## Service Bulletin

**SB 21-3**  
**6-25-81**

SUBJECT: CLUTCH PRESSURE PLATE  
VEHICLES: 308 GTSi and GTBi Models  
SERIAL NOS: Starting with the following serial number.

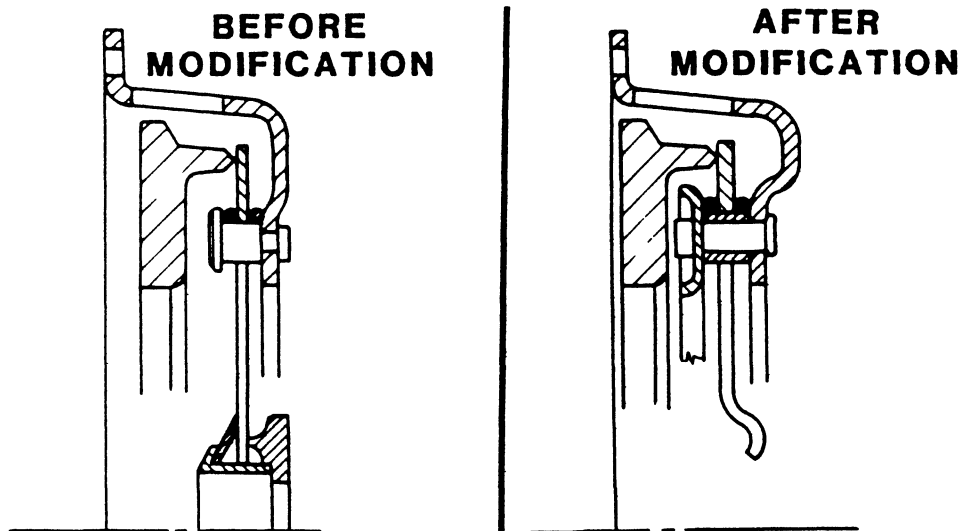
The configuration of the clutch pressure plate has been changed.

The diaphragm spring fingers of the new pressure plate are now curved and in direct contact with the release bearing.

Important: The new pressure plate must only be used on vehicles with "self-adjusting clutch release system."
